CITY of NOVI CITY COUNCIL

Agenda Item 3

SUBJECT: Consideration of a deviation from Subdivision Ordinance, Appendix C, Section 4.04 for the lack of a secondary connection at an interval exceeding one thousand three hundred feet for the site plan associated with Woodbridge Park (parcel 50-22-26-300-015) located at the northeast corner of Nine Mile and Novi Road.

TO: PETE AUGER, CITY MANAGER
THRU: BARBARA MCBETH, AICP, CITY PLANNER
FROM: SRI RAVALI KOMARAGIRI, PLANNER
SUBJECT: JSP 17-67 WOODBRIDGE PARK
DATE: MAY 15, 2019

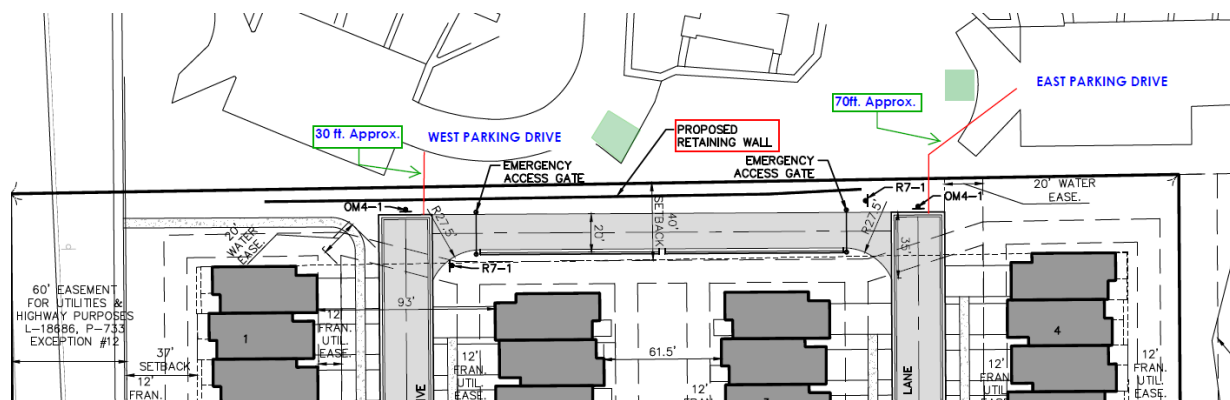
patterns in the area. Exhibits include plan and cross-sections at the end of the Osprey Drive and Woodbridge Lane, site photographs and few other references. Below is an aerial image that shows the existing conditions at the property boundary in discussion.

There are two possible locations to provide a stub street to the existing apartment community (Saddle Creek) to the north as shown in the image below. There is approximately 30 feet from edge of pavement from Osprey Drive to potential connection point to the western parking drive in Saddle Creek and about 70 feet from Woodbridge lane to potential connection to the eastern parking drive.

The applicant notes that Woodbridge Park requires a retaining wall along much of the north property line, amounting to 315 feet (indicated as red line in the image below). The applicant states that it is impractical to extend Osprey Drive (on the west) due to potential conflict with the proposed 3 foot retaining wall along northern property line. The applicant's response letters include a cross-section that demonstrates the conflict. It appears that the extension of Woodbridge Lane (on the east) to connect to the

OSPREY DRIVE STUB (A-A)

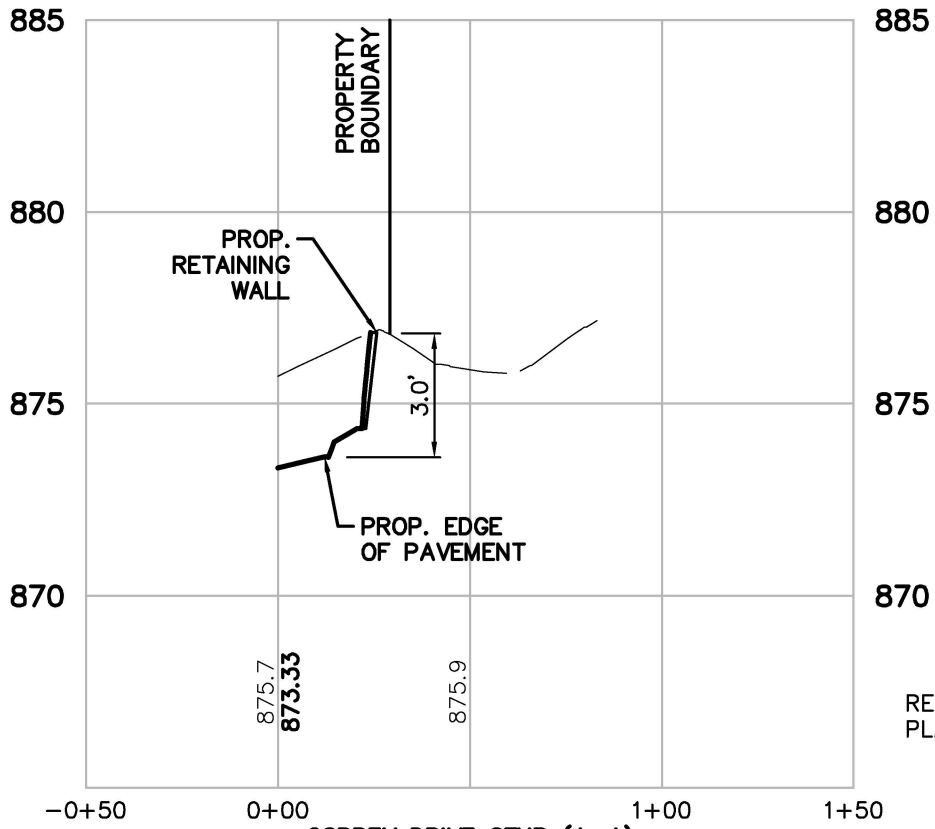
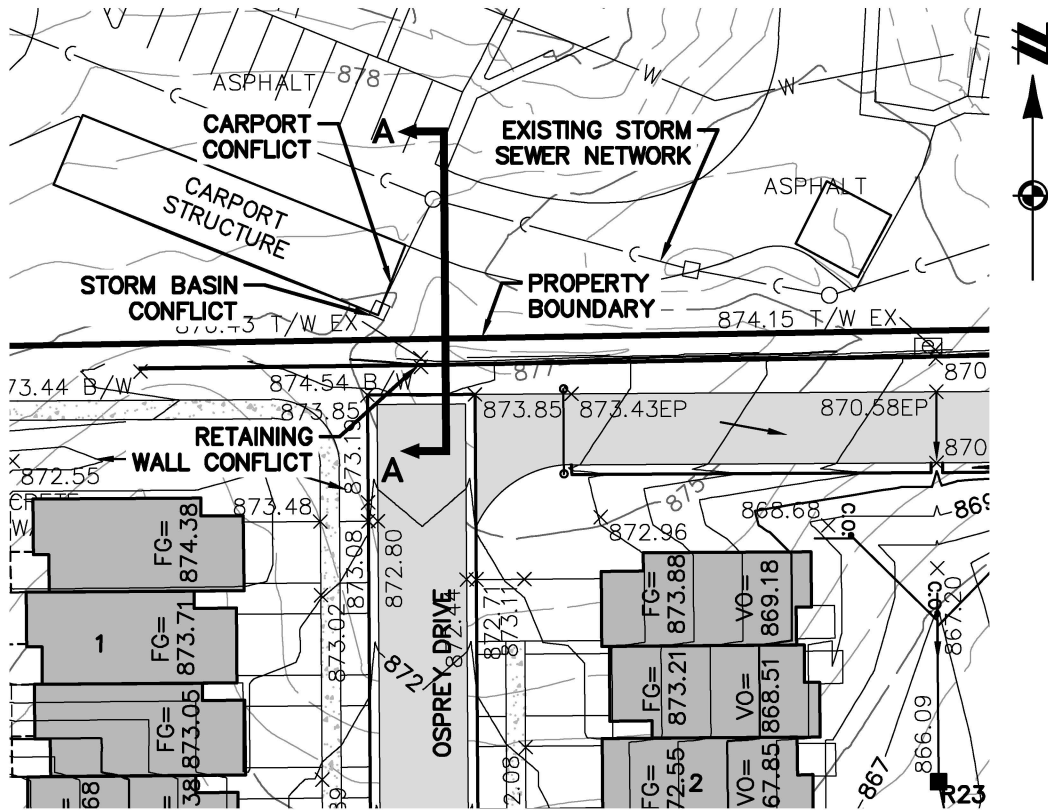
Woodbridge Park requires a retaining wall along much of the property boundary to the north (315 linear feet of wall) to make up the topography differences between the proposed Woodbridge Park development and the existing grade along this north property boundary. Extension of the end of Osprey Drive street toward the adjoining property would conflict with the proposed retaining wall required in this area. The end of Woodbridge Lane is approximately 3 feet above the existing grade elevation at the adjoining property boundary to the north. Extension of the end of Woodbridge Park would require fill to be placed at the end to the street to match existing grade. This fill would block the existing yard basin in the area and would require reconfiguration of storm sewer and drainage patterns on the Saddle Creek property.

WOODBIDGE LANE STUB (B-B)

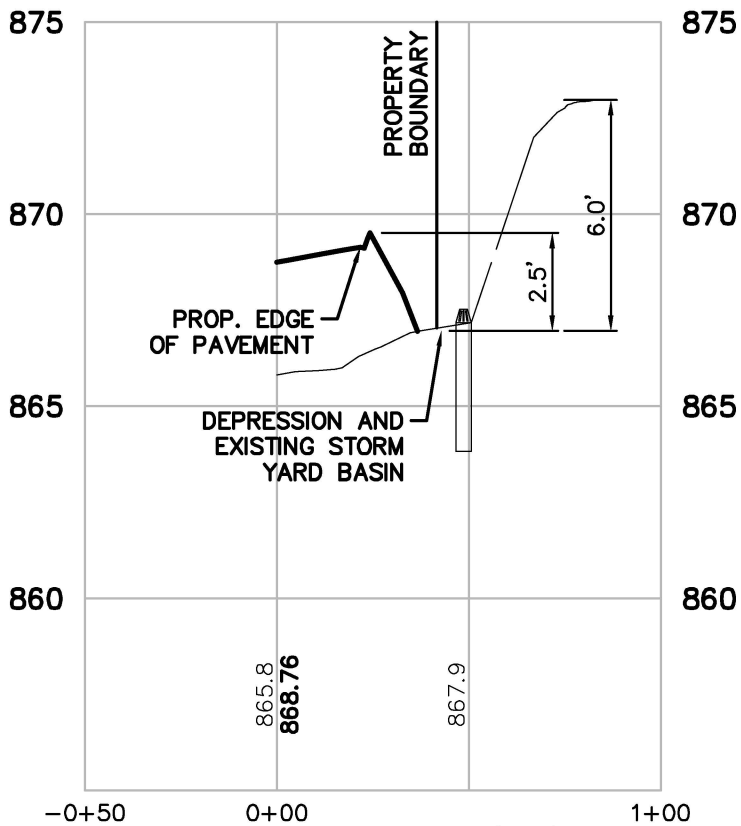
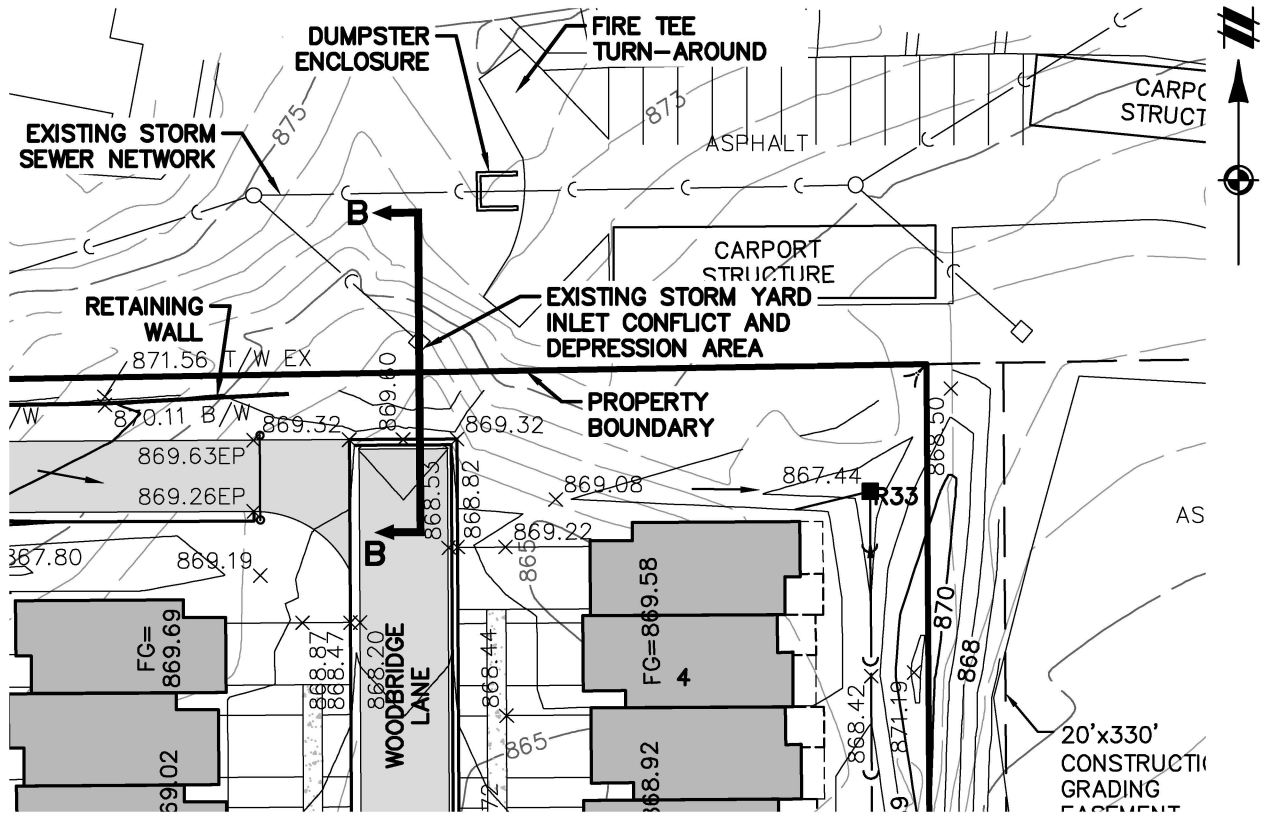
response letters include a cross-section that demonstrates the conflict. It appears that the extension of Woodbridge Lane (on the east) to connect to the existing drive in Saddle Creek apartments would require fill to be placed at the end of the street to match the existing grade. The applicant states that any proposed fill would block the existing yard basin in Saddle Creek, would require reconfiguration of the storm sewer and would modify the existing drainage patterns on the Saddle Creek property. Further, if Saddle Creek were to consider making a street connection, it would most likely result in removal and relocation of existing carports, reconfiguration of storm sewer and drainage patterns in the area, removal of tee-turnaround, and relocation of the existing dumpster and dumpster enclosure, according to the applicant's analysis of the situation.

Site Photograph: Parking and Carport Access Area on Saddle Creek Property, North of Woodbridge Lane

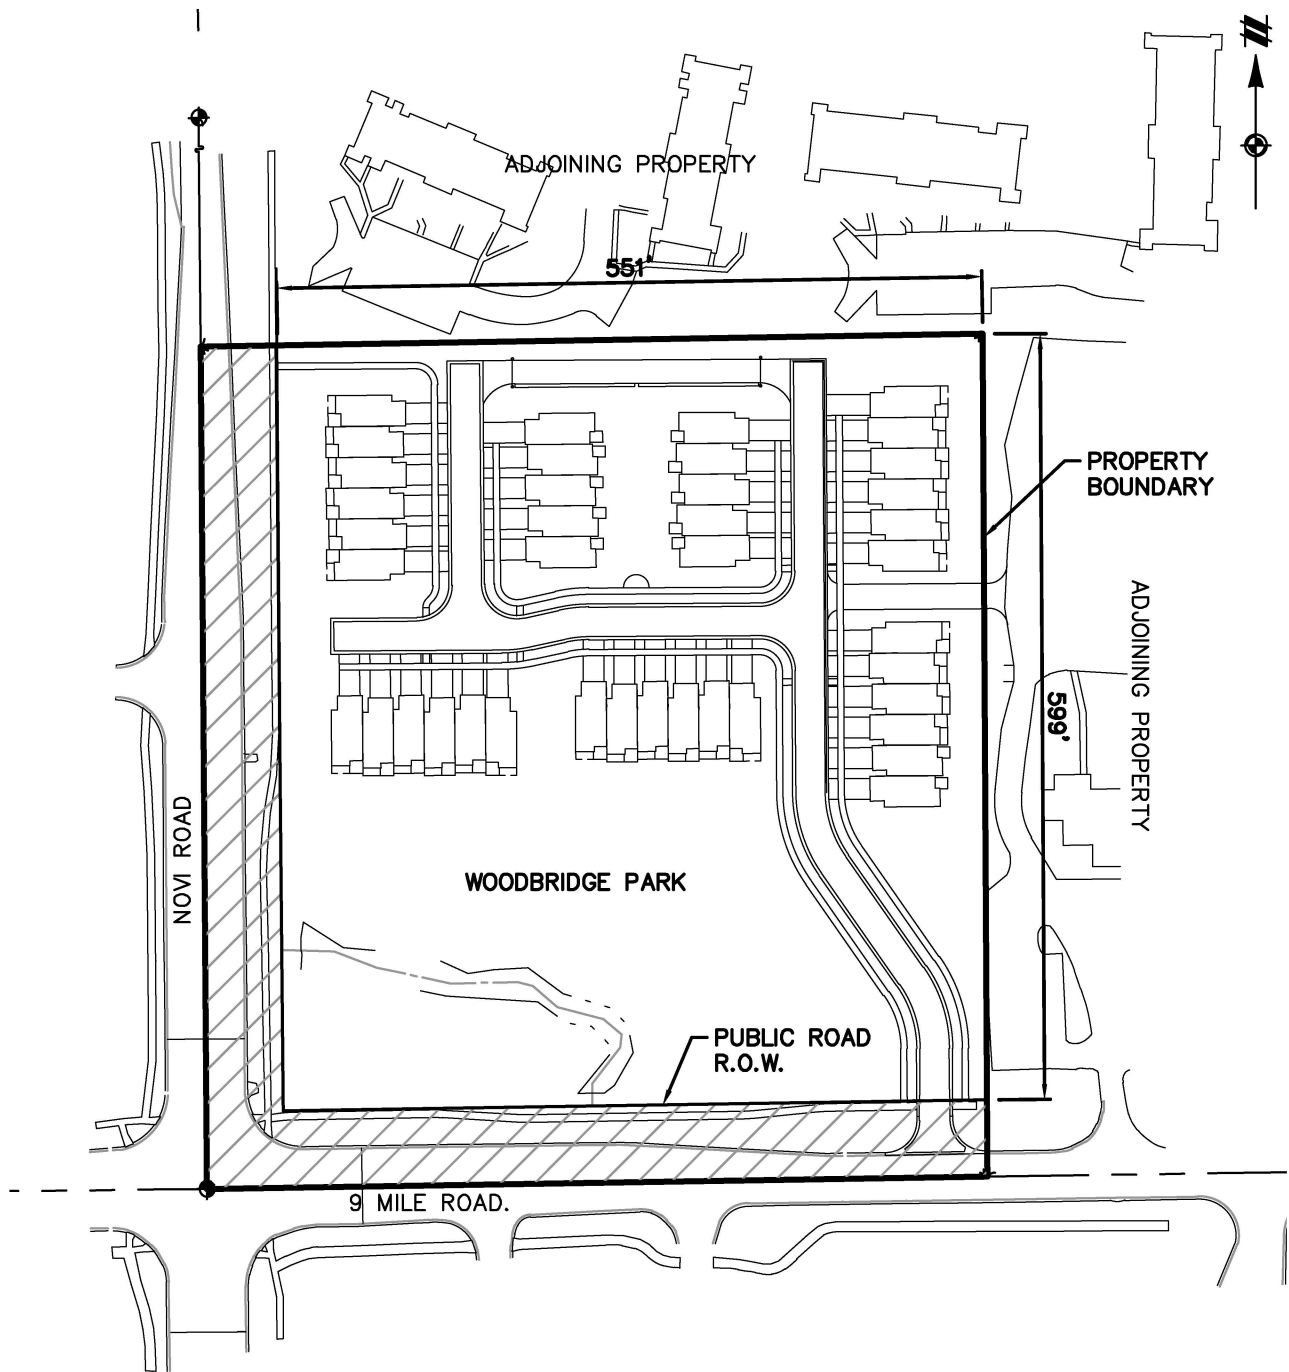
Stub streets for cross-access were not provided with the development of Saddle Creek. The parking access drives and alleyways associated with the Saddle Creek development were also not planned or designed to function as local street cross-connections between adjoining properties. Whether or not the physical site modifications required to make a future connection the Saddle Creek development are constructible (i.e. removal and relocation of existing carports, reconfiguration of storm sewer and drainage patterns in the area, removal of tee-turnaround, and relocation of the existing dumpster and dumpster enclosure location), the existing vehicular pavement areas are not in compliance with the City standard widths required for local streets as defined by “Figure IX.1 – Design Standard for Two-Way Driveway and Local Streets” (Ord. No. 99-124.11, Pt. XXXIII, 7-26-99). In accordance with Figure IX.1, local streets are required to be have a 28 feet width, as measured from back-to-back of curb. Many areas along the existing vehicular thoroughfares in the parking areas are less than 24 feet back-to-back, with some areas only 21 or 22 feet wide. This geometry is not in compliance with City ordinance to qualify as a local street.
